<b>marantz®</b> <b>SERVICE BULLETIN</b>		Date: 15-May-2003	Model: SR5200/SR6200/SR7200
		Page: 1/2	REF.NBR: MZ02-033
Circulation:		Subject:	
Application:		Hum noise can be heard from Headphone out.	
x for information customer complaint in case of service mandatory			
See below

<b>marantz®</b> <b>SERVICE BULLETIN</b>		Date: 15-May-2003	Model: SR5200/SR6200/SR7200
		Page: 1/6	REF.NBR: MZ02-032
Circulation:		Application:	
x for information customer complaint in case of service mandatory		See below	
		Subject:  Pop noise	
		Int.ref:

<b>marantz®</b> <b>SERVICE BULLETIN</b>		Date: 15-May.-2003	Model: SR5200,SR6200,SR7200
		Page: 1 / 1	REF.NBR: MZ02-027
Circulation:		Subject: Video synchronization problem.	
Application:		Int.ref:	
x for information customer complaint in case of service mandatory .....		See Below

<b>marantz®</b> <b>SERVICE BULLETIN</b>		Date: 15-May.-2003	Model: SR5200,SR6200,SR7200
		Page: 1 / 1	REF.NBR: MZ02-039
Circulation:		Application:	
x for information customer complaint in case of service mandatory .....		See Below	
		Subject: The damage of the power transistor	
		Int.ref:

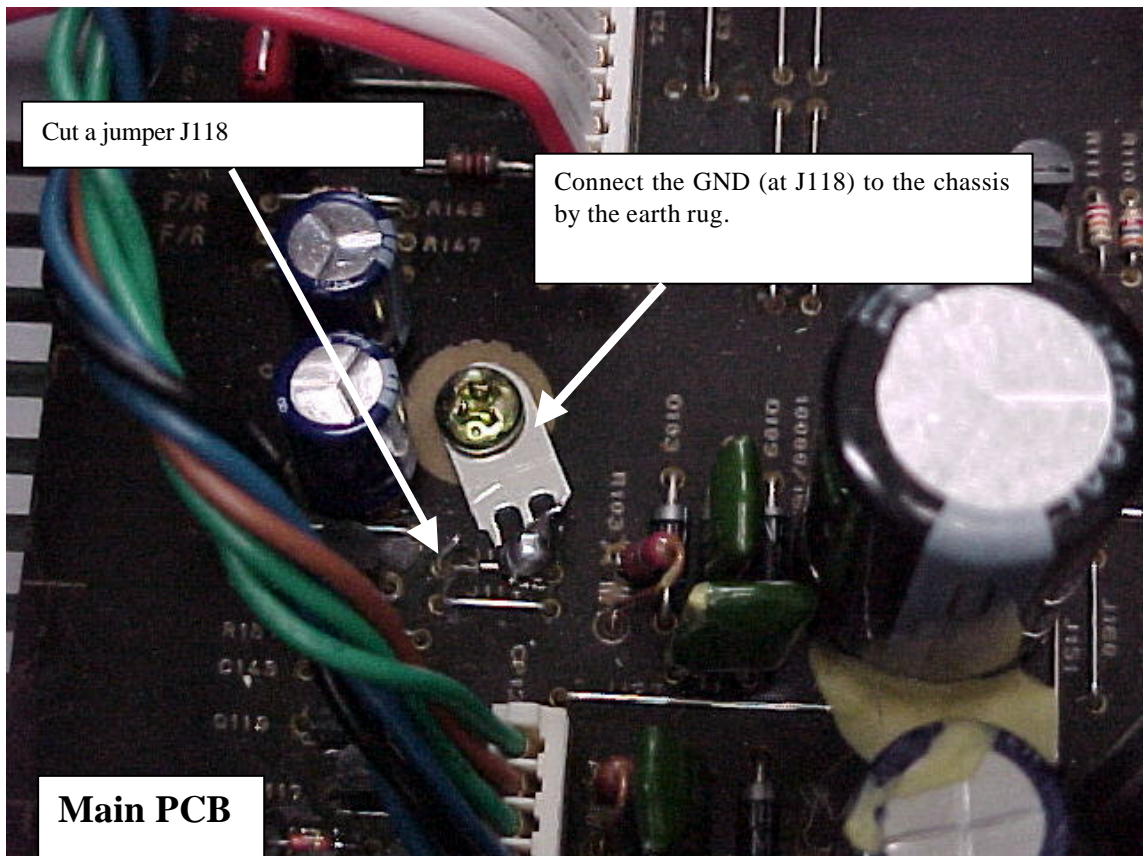
Hum noise can be heard from Headphone out

Caused by ground loop of the headphone out.

Please apply the following solution.

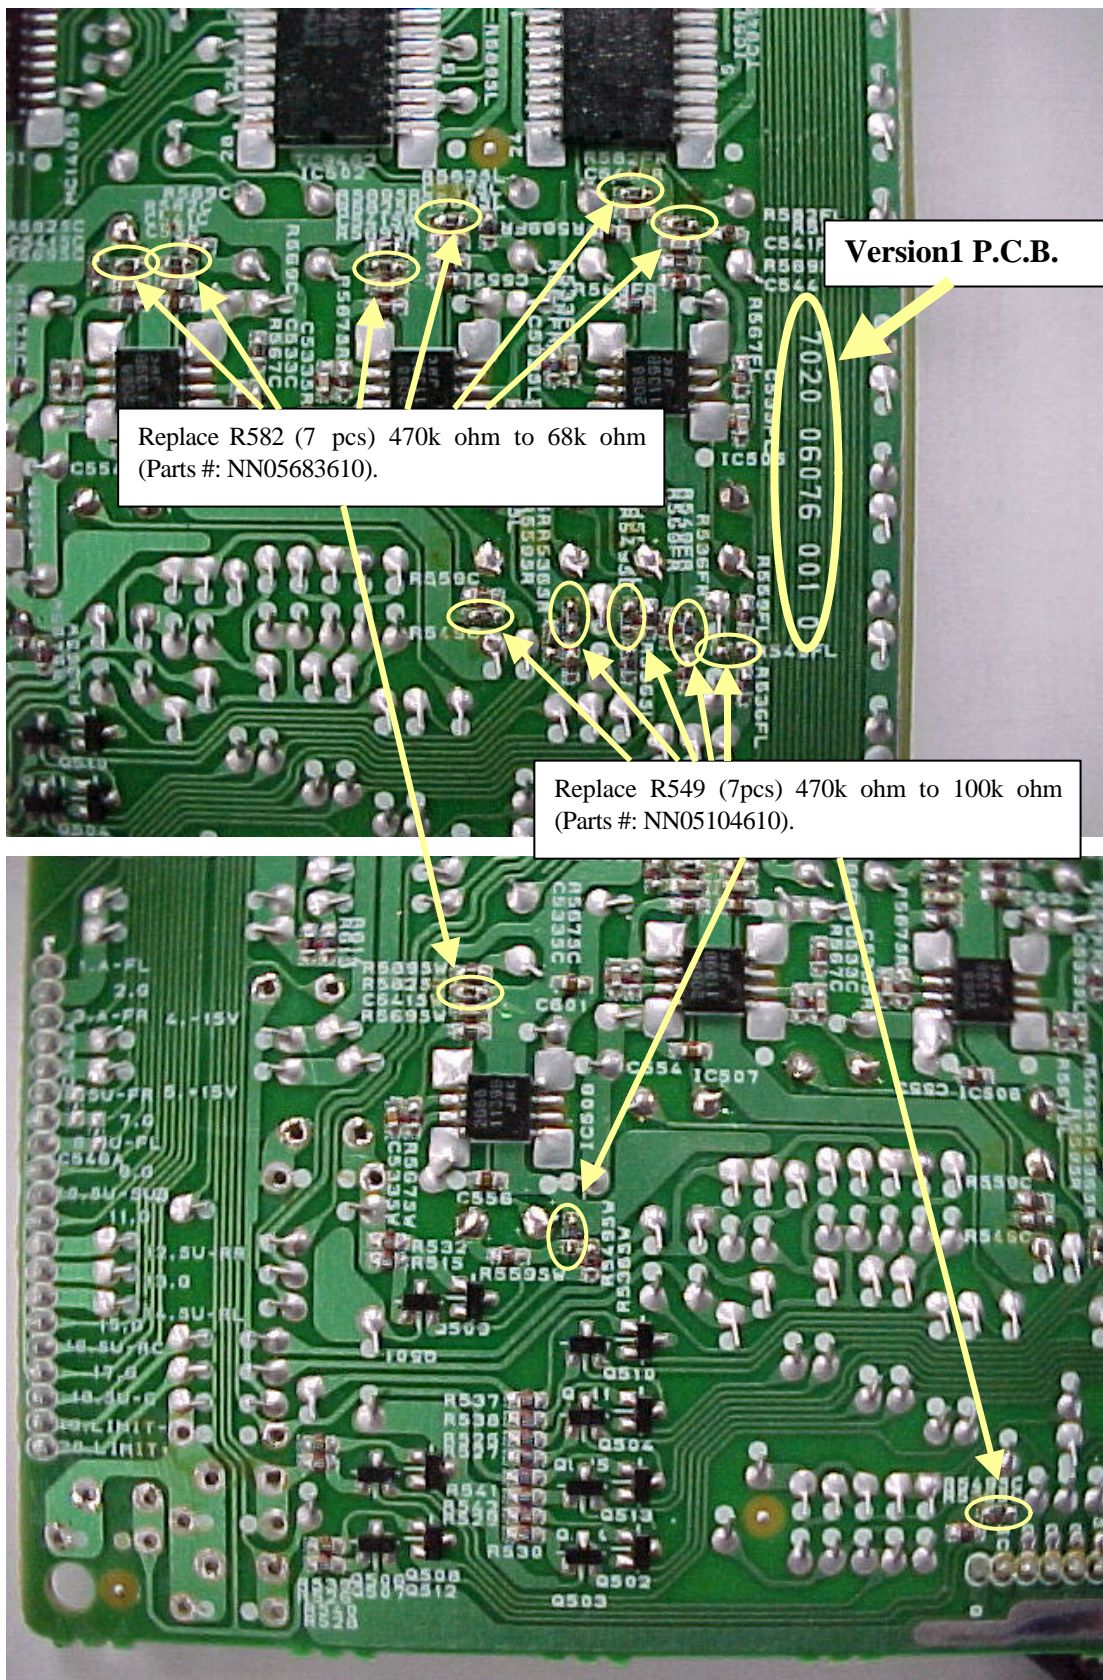
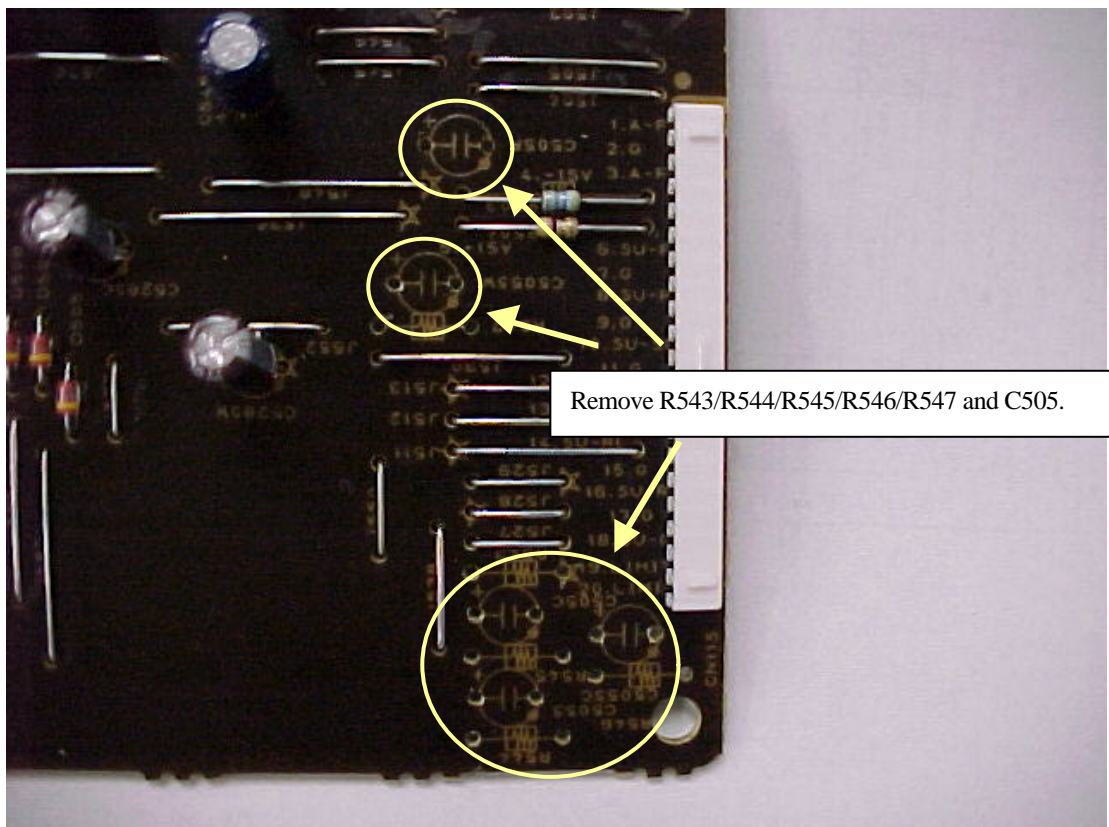
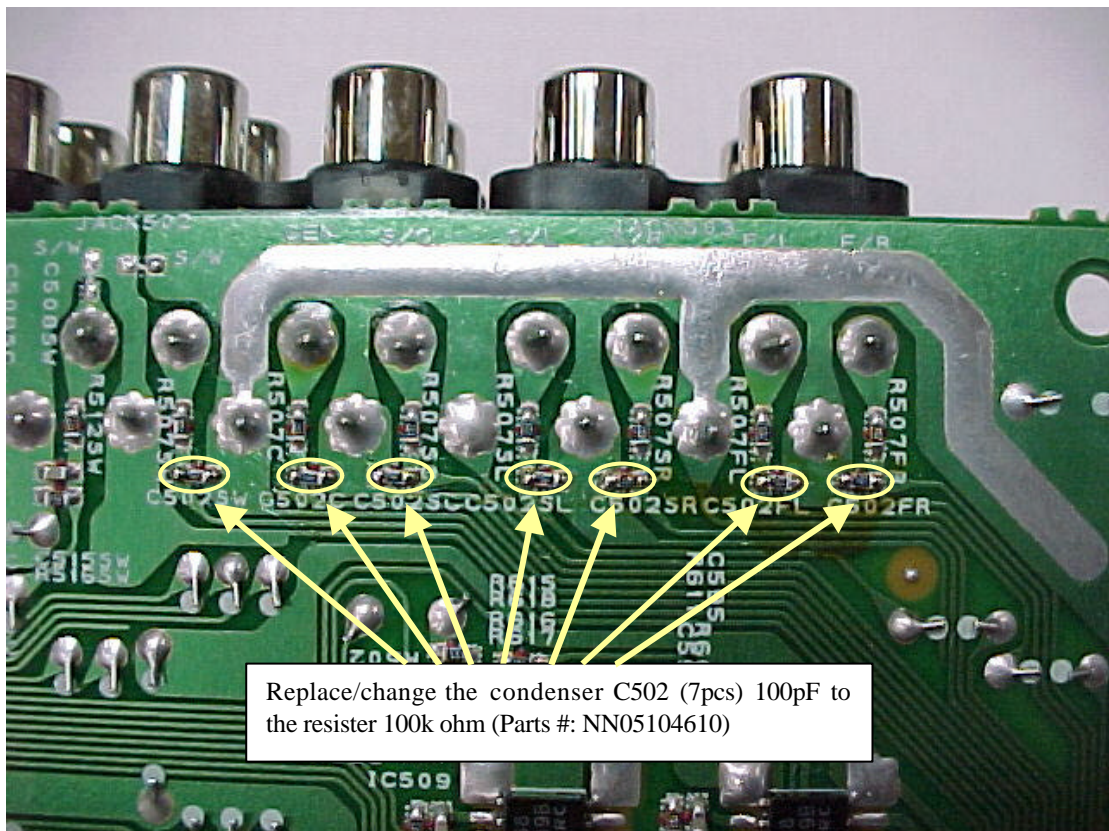
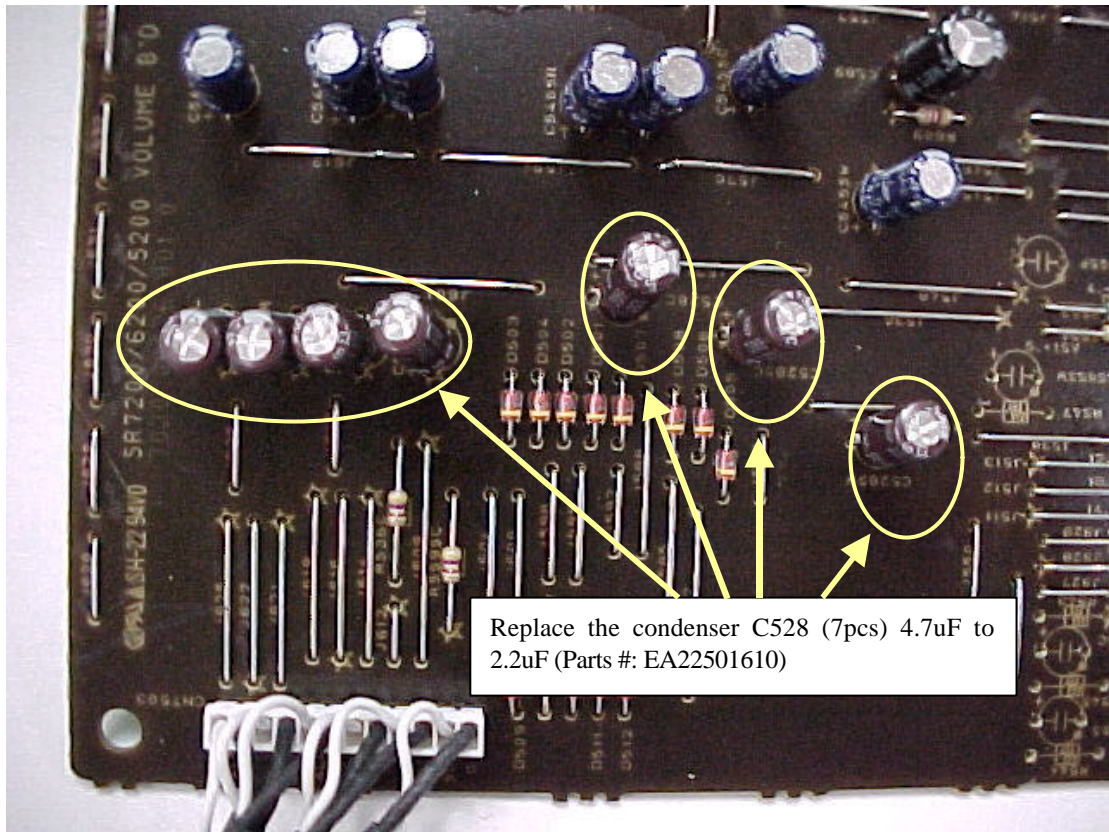
Pop noise appears when stop playing or track skip on CD playback with Digital connection.  
Pop noise appears in the condition of the Main volume is changed 74dB to 75dB(Mute) .

[**Caution**] Modifications are deferent with version of the P.C.Board.

\* Version 1 P.C.Board (7020 06076 001-0) : Please apply the modification mentioned below (Page2 to 4).

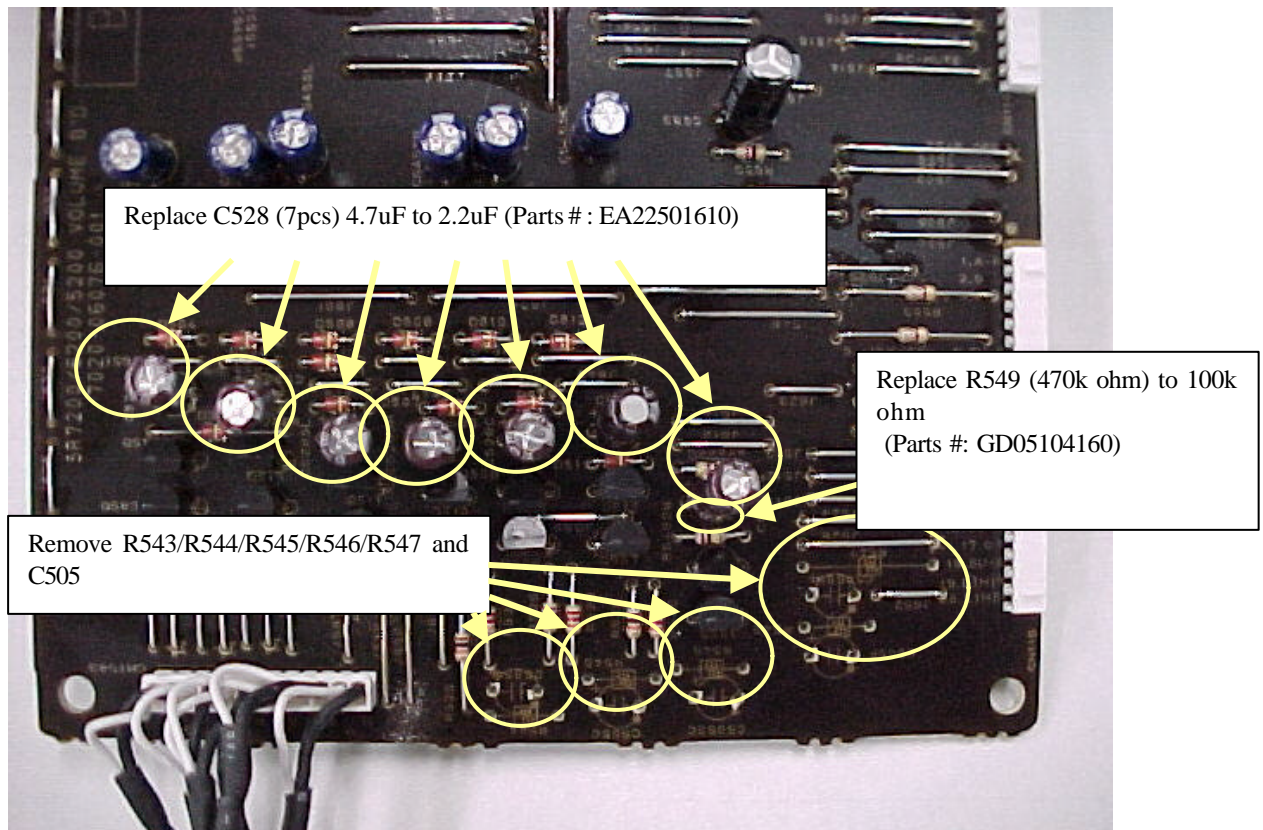
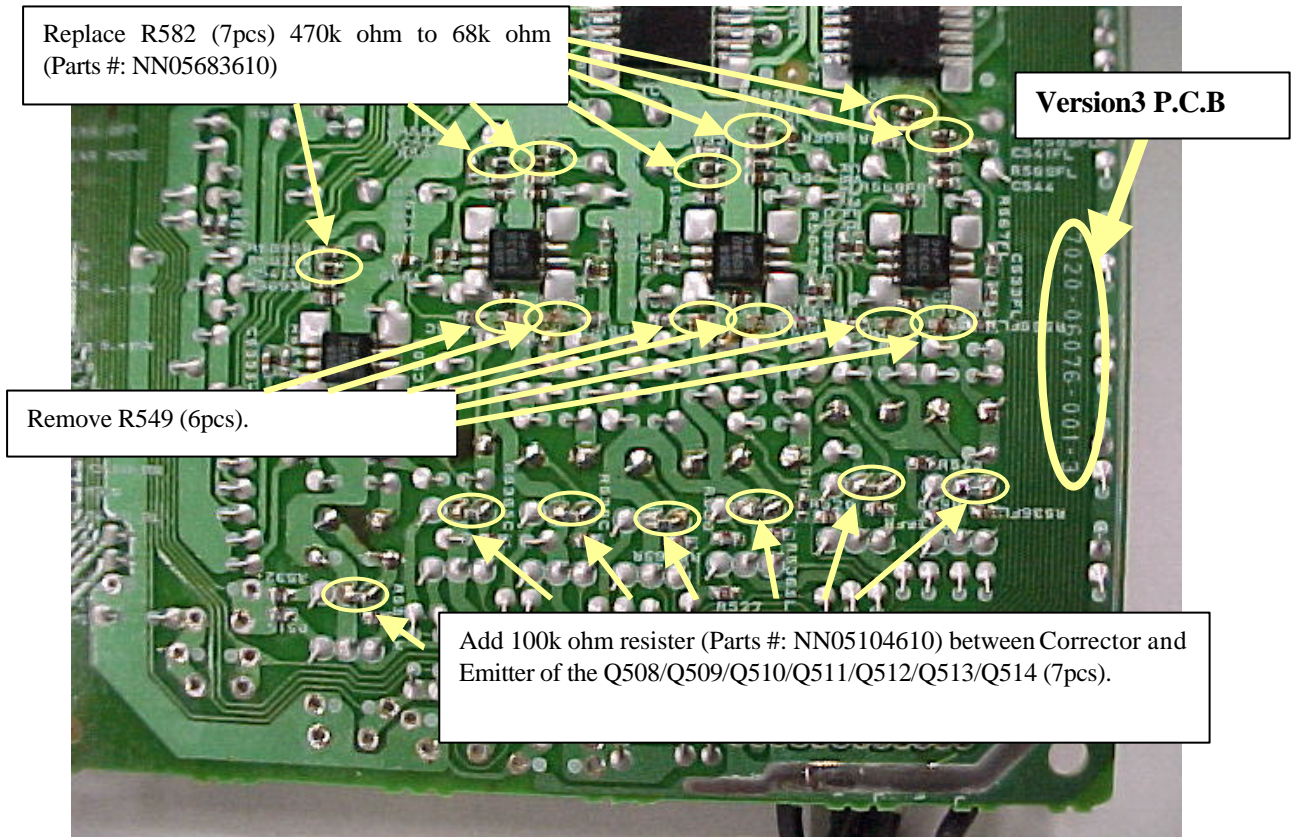
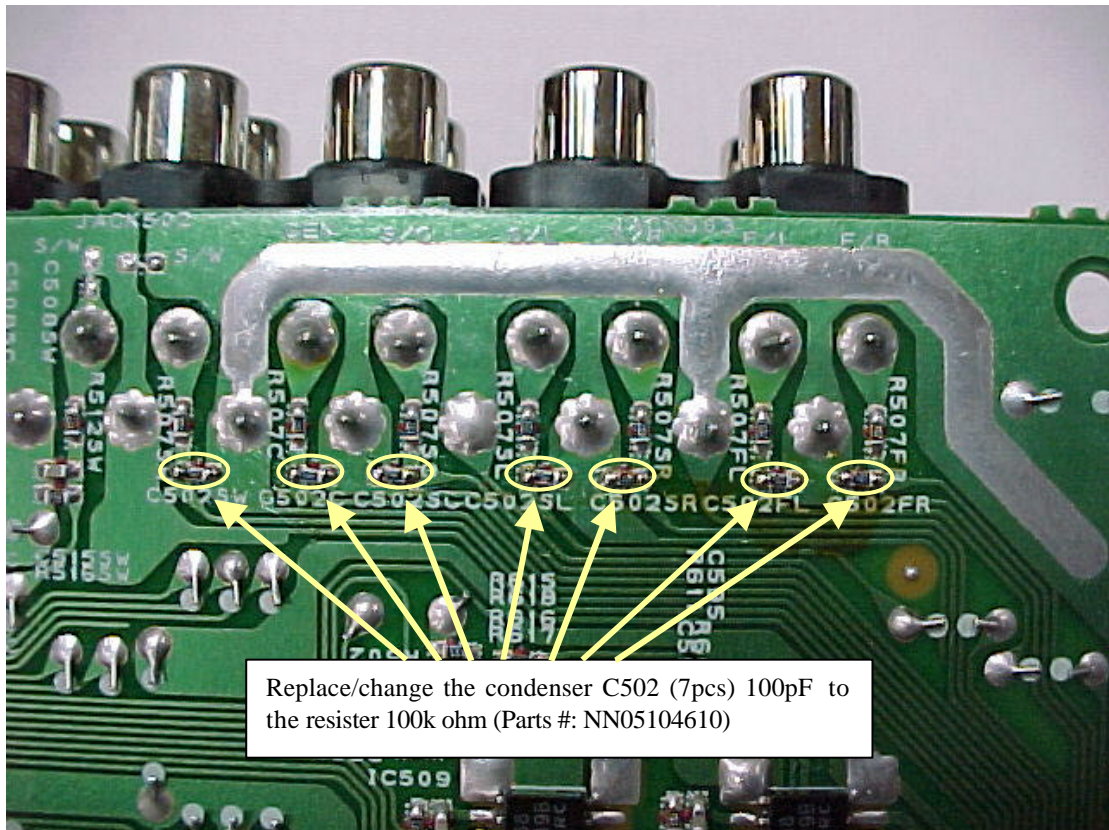
\* **Version 3 P.C.Board (7020 06076 001-3)** : Please apply the modification mentioned below (Page 5 to 6).

Replace/change the condenser C502 (7pcs) 100pF to the resistor 100k ohm (Parts #: NN05104610)

PIC.01

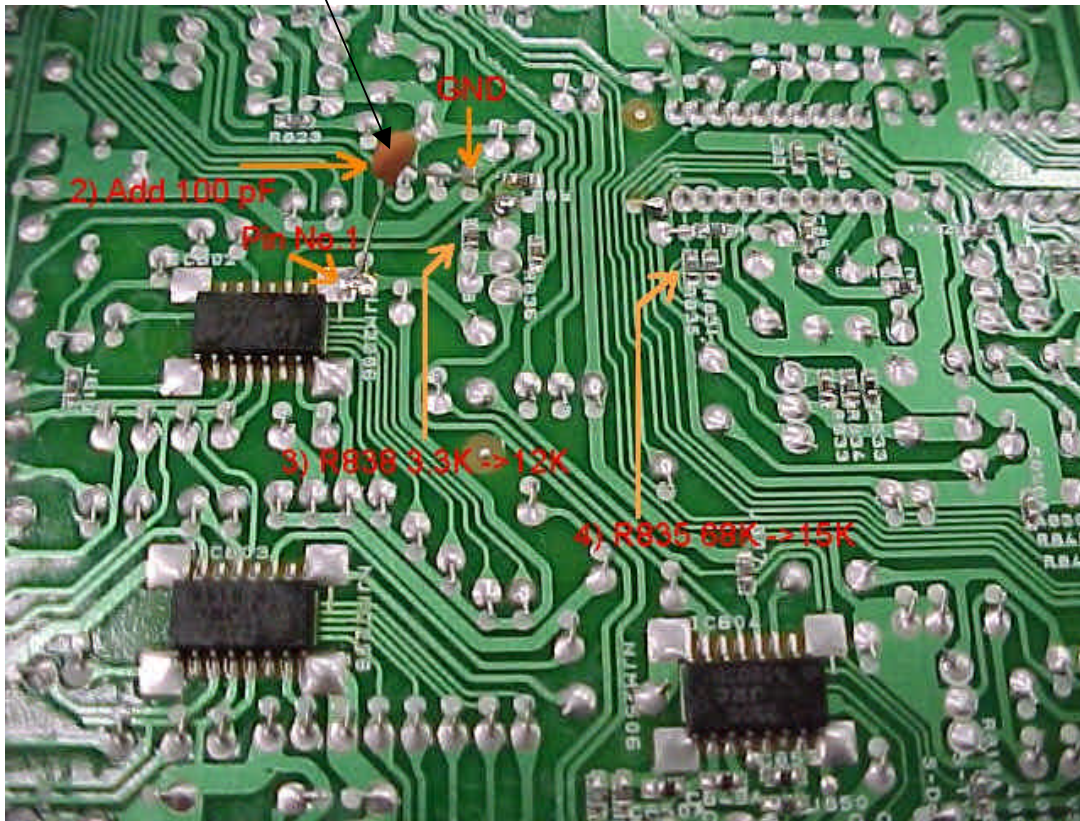
- 1) The capacitor(C810A 100pF: DK16101300 4822 122 33195) is added between 1P of IC802 and GND(refer to PIC.01).
- 2) The jumper wire(J841) is deleted and a capacitor(C840A 47uF/16V: EA47601620 9965 000 06289) is added to same position (refer to PIC.02).
- 3) The chip resistor(R838) is changed into 12kohm one(NN05123610 4822 051 30123) from the present 3.3kohm one.
- 4) The chip resistor(R835) is changed into 15kohm one(NN05153610 4822 051 30153) from the present 68kohm one.

C810A (100pF: DK16101300

4822 122 33195)
